Document No.
IM-2015-000152 (Non-Proprietary)

Response to the Action Items from January 28, 2015 Meeting on Toshiba FPGA LTR

Note :  
 This document provides responses from Toshiba to the U.S. Nuclear Regulatory Commission (NRC) related to the action items from the January 28, 2015 meeting on the Toshiba Field Programmable Gate Array (FPGA) Licensing Topical Report (LTR).

**Figure 3.18-1 Signal Processing of Watchdog Timer for CELL module HMI FGAs**

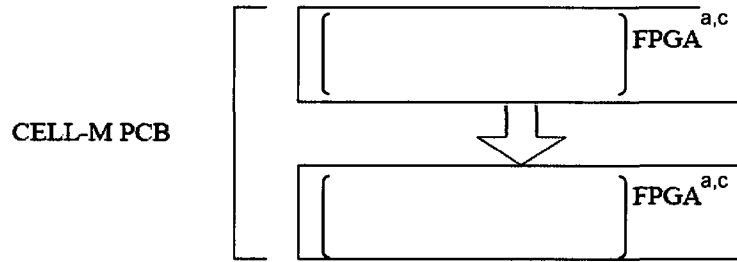
Provide diagrams for signal processing of watch-dog timers.

The watchdog timers of the CELL module are explained as an example. The CELL modules has two watchdog timers, one for FPGAs performing HMI function, and the other for FPGAs performing signal processing. Figure 3.18-1 is a diagram the signal chain of HMI FPGAs of the CELL module. The watchdog timer monitors the End of Processing (EOP) signal when it is passed from the [ ]<sup>a,c</sup> FPGA to the [ ]<sup>a,c</sup> FPGA. The watchdog timer generates a minor failure alarm if the timer expires for the HMI FPGA signal chain.
